***ACCESS REPORT***  
***1289 PITTWATER ROAD***  
***NARRABEEN NSW 2101***

**Double storey 3 residential units and converting to class 2 building**

Report: **A242086-R1.1**  
Date: **7 January 2025**  
Prepared for: **Richard Wood**

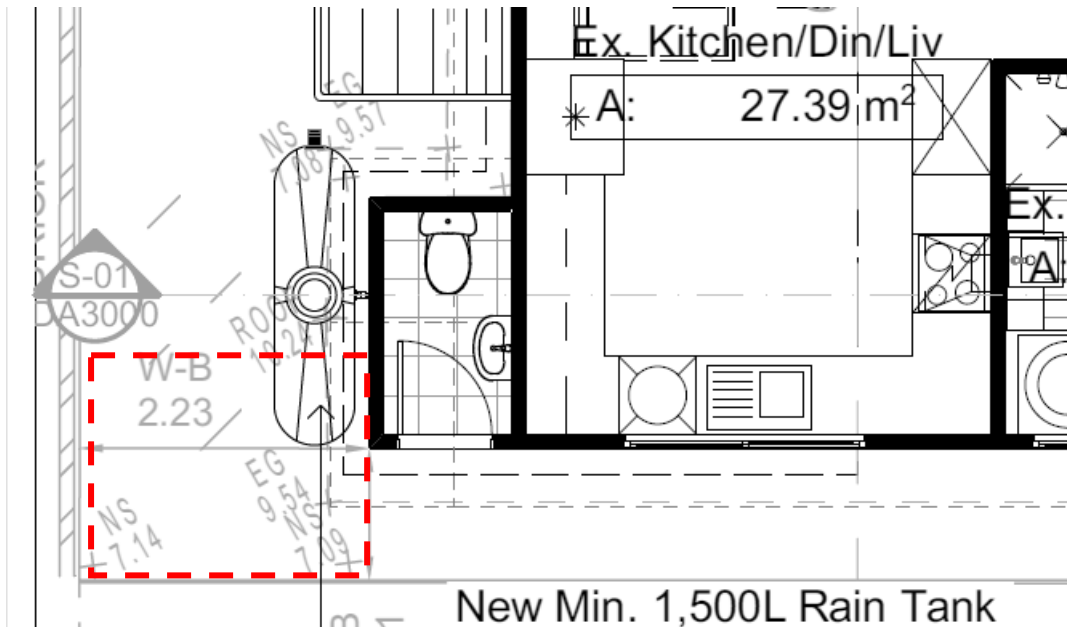
An accessway has been provided to Unit 1. Unit 2 is also required to feature an accessway to the entry door of that unit as this apartment is located on the same level as Unit 1. Plans also show cloths lines and a sanitary facility at the common area at rear of the building.

Compliance is achievable providing the requirements of clauses D4D3 to D4D13 are met by DTS compliance outlined below or by performance solution.

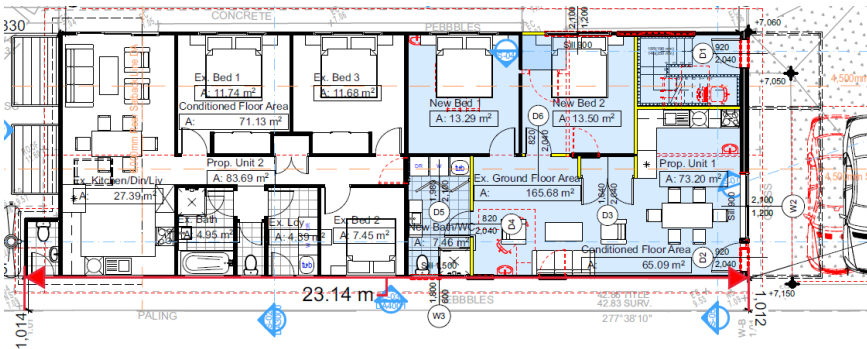
Landscape plans confirm that there is a grass area following the accessway to the sanitary facility. Accordingly the accessway, which is approximately 23 m, will require a turning space of 2070 mm x 1540 mm at the end as well as within the accessway. A modification of the design or performance solution is needed to address this requirement.

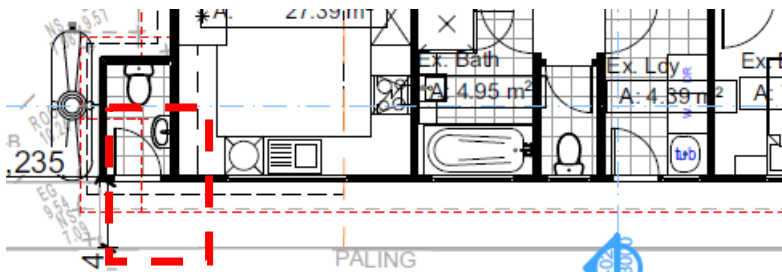
The door to the common sanitary facility is not provided with latch-side clearance, length clearance from the property boundary, or clearance from the washbasin. A modification of the design or performance solution is required to address this deviation.
